PRELIMINARY STORMWATER REPORT

# The Osprey

7440 159<sup>th</sup> PI NE  
Redmond, Washington 98052

DCI Job No. 19012-0002  
June 7, 2019  
Revised: September 13, 2019  
November 13, 2019  
December 20, 2019  
March 16, 2020

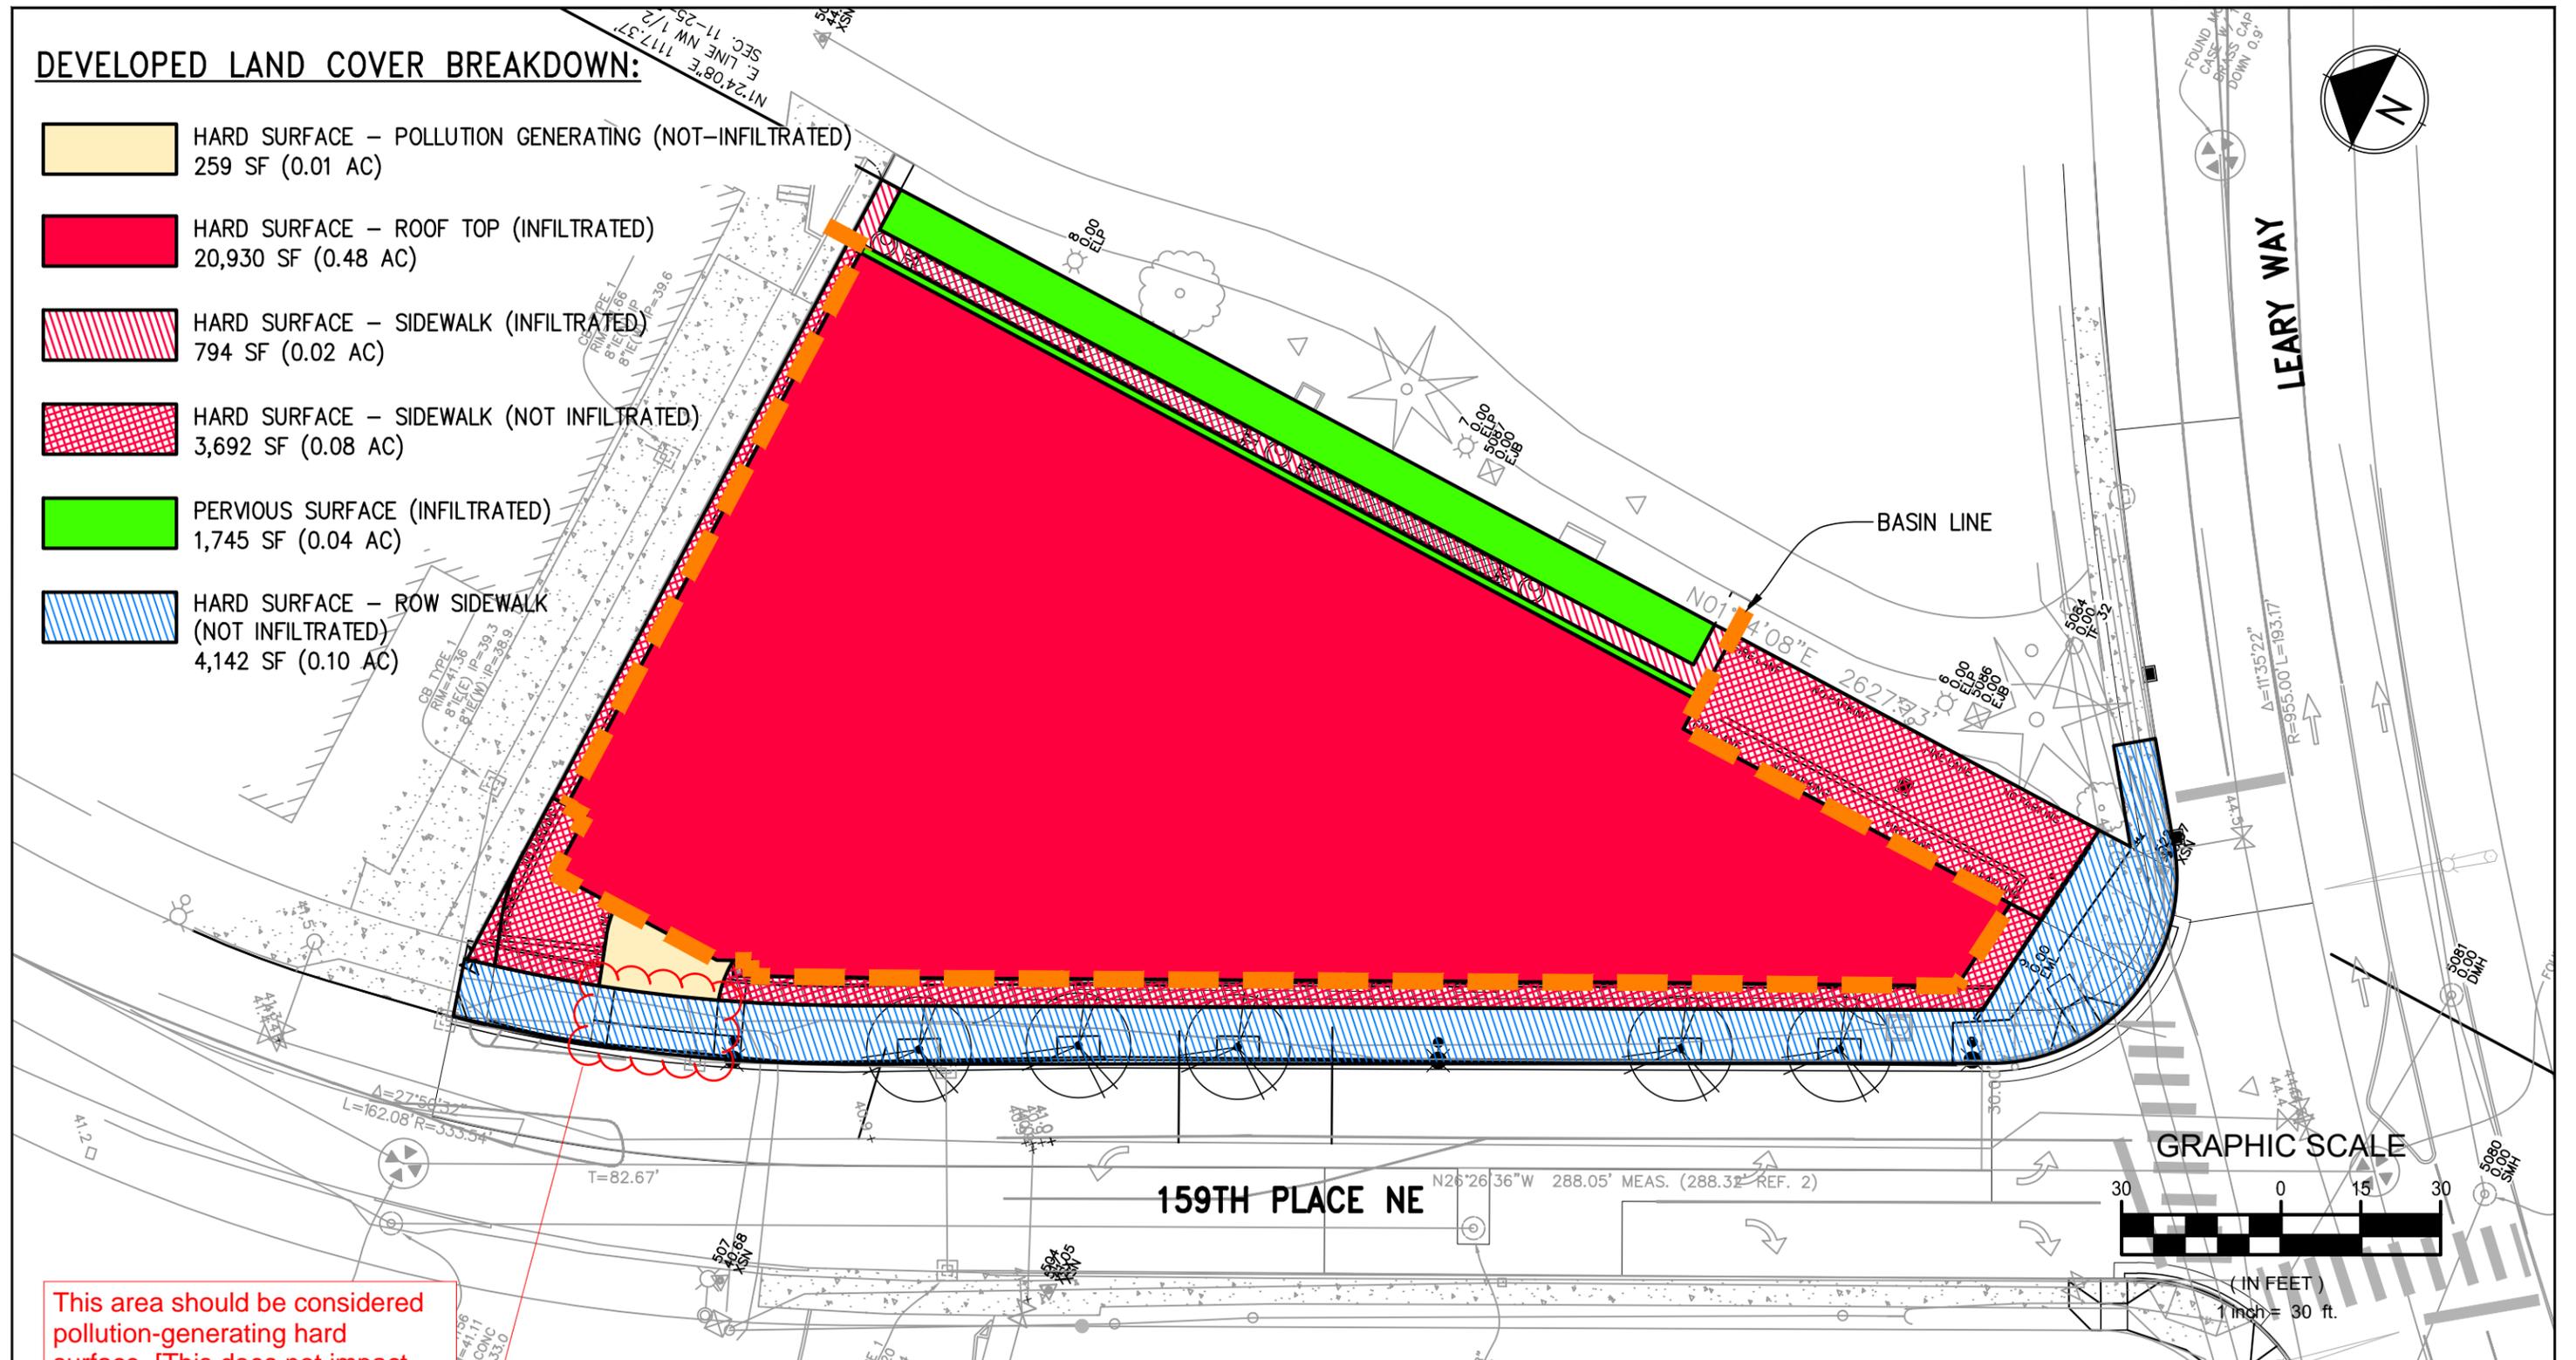
This area should be considered pollution-generating hard surface. [This does not impact site feasibility and may be addressed during CCR]

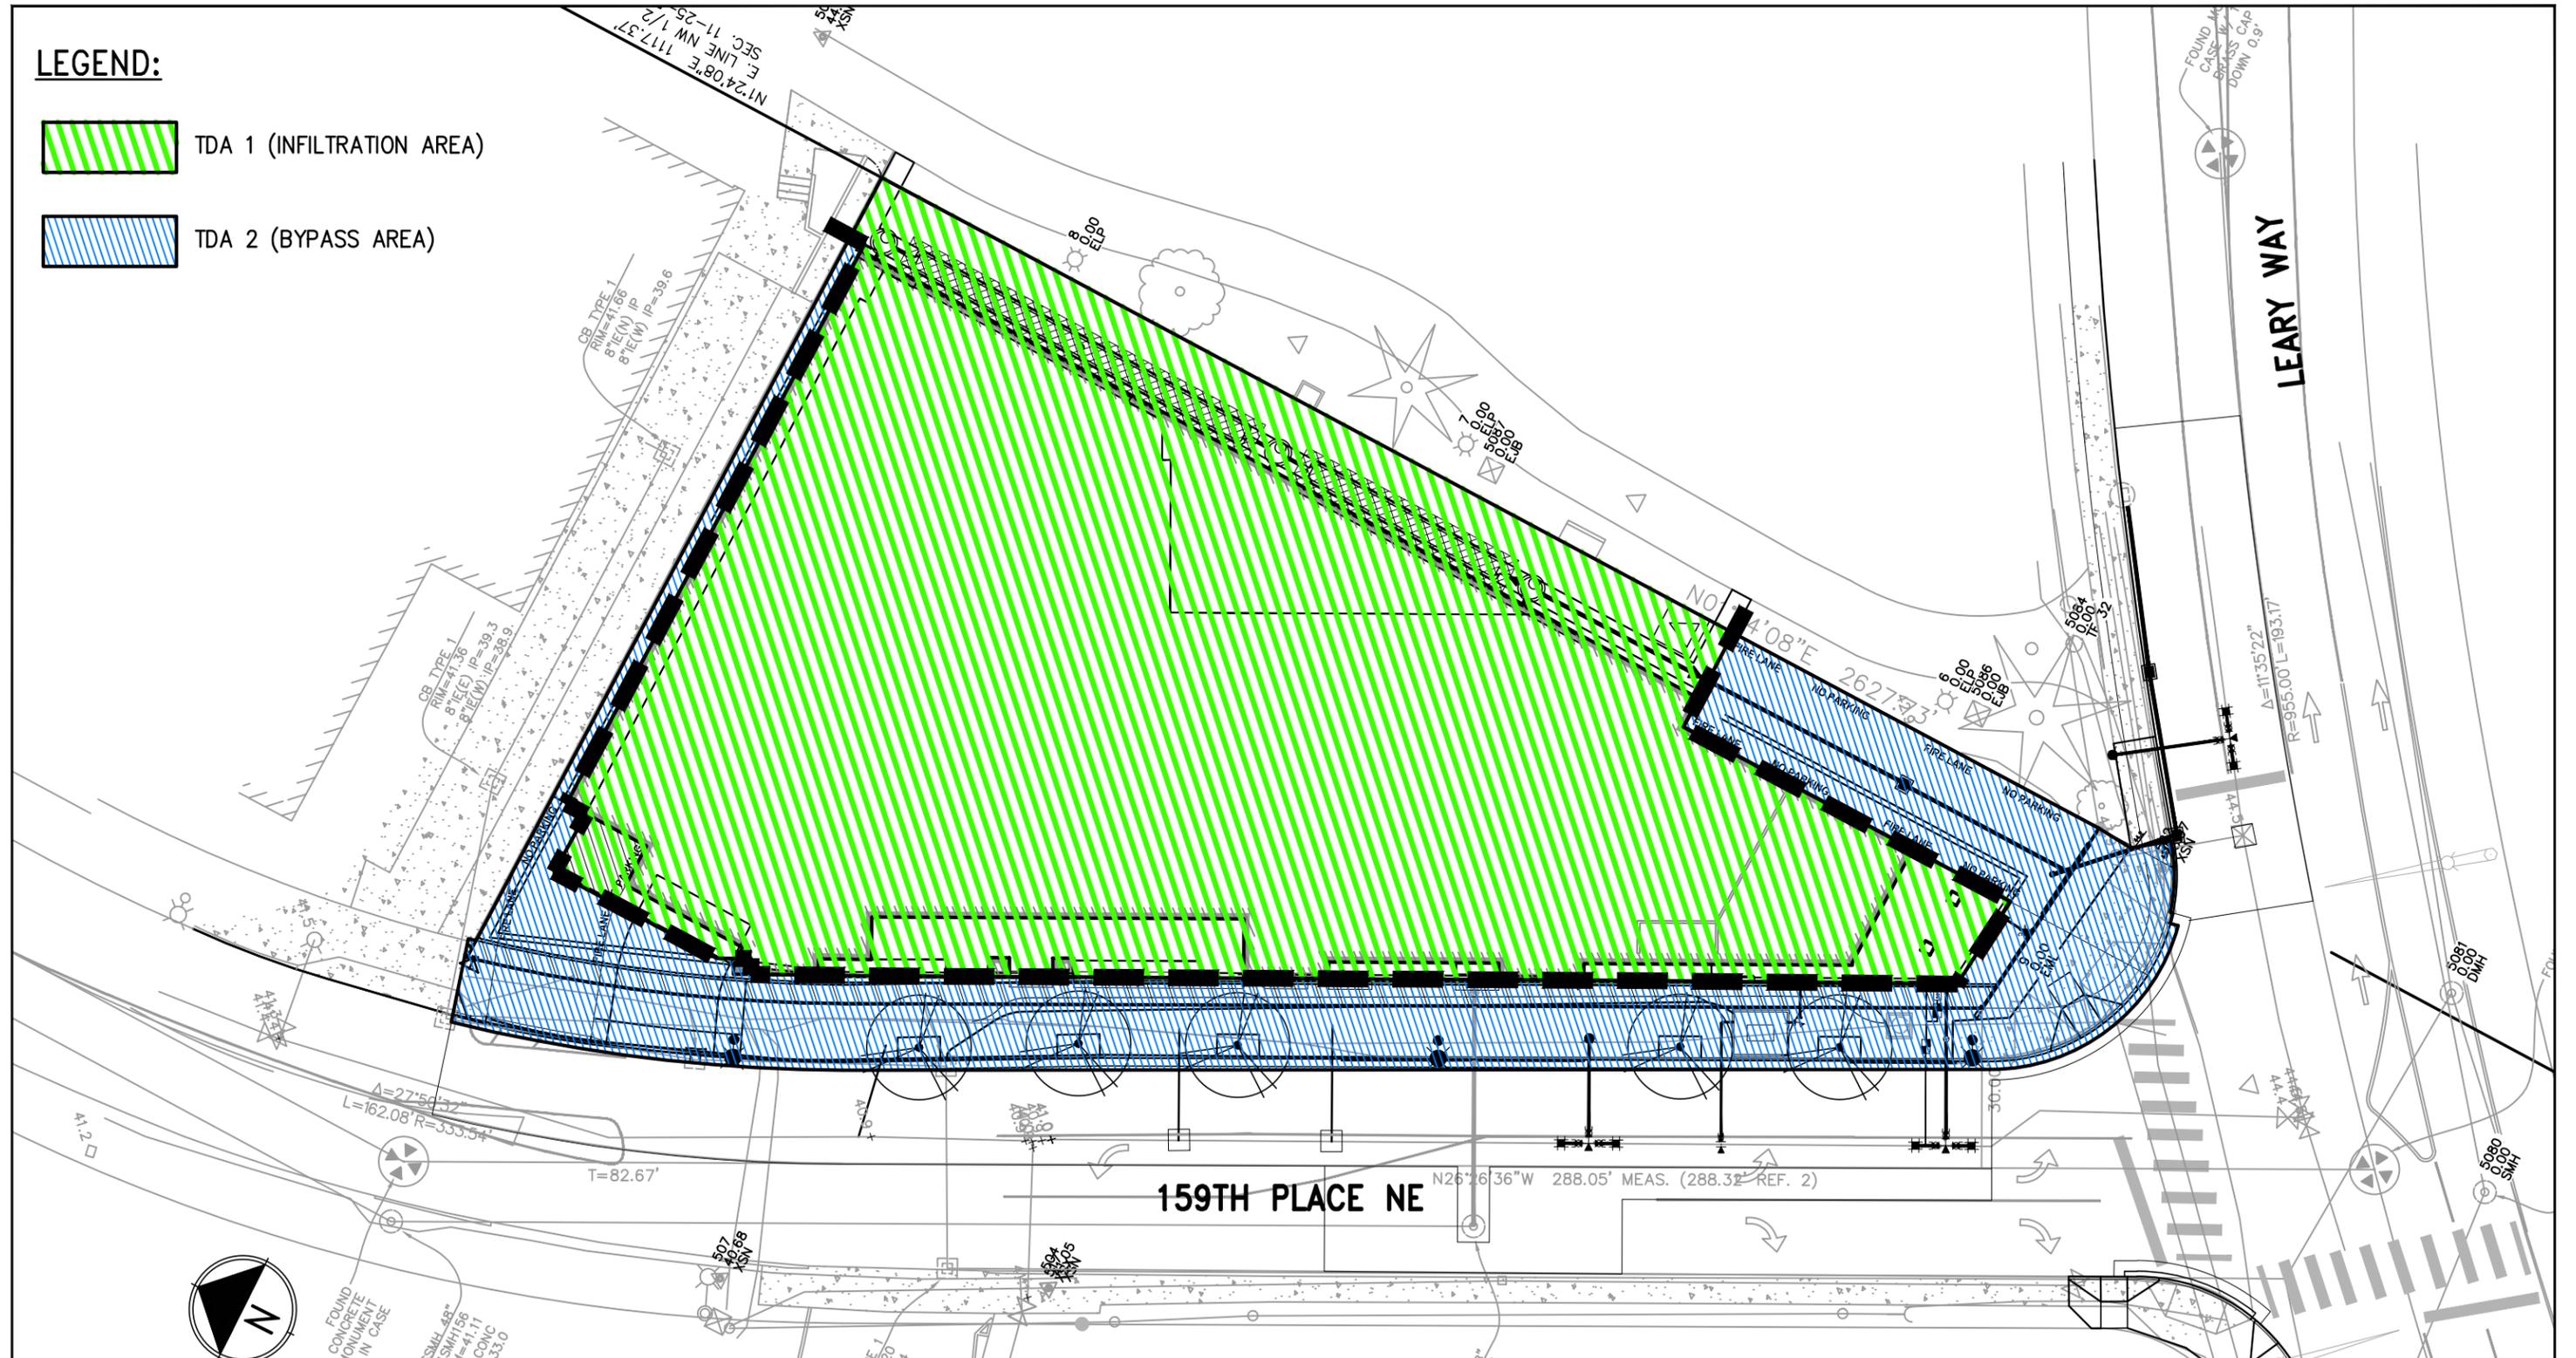
The exhibits show bypass areas for the infiltration system (emergency vehicle access, sidewalk, driveway, etc.). The calculations provided here should reflect that bypass. Since you're within the downtown system, the flow control requirement won't be an issue, but we will need to confirm that the bypass flows can be safely handled by the existing storm system. Given current site configuration and a lack of any known drainage problems in this area, this can be addressed during CCR.
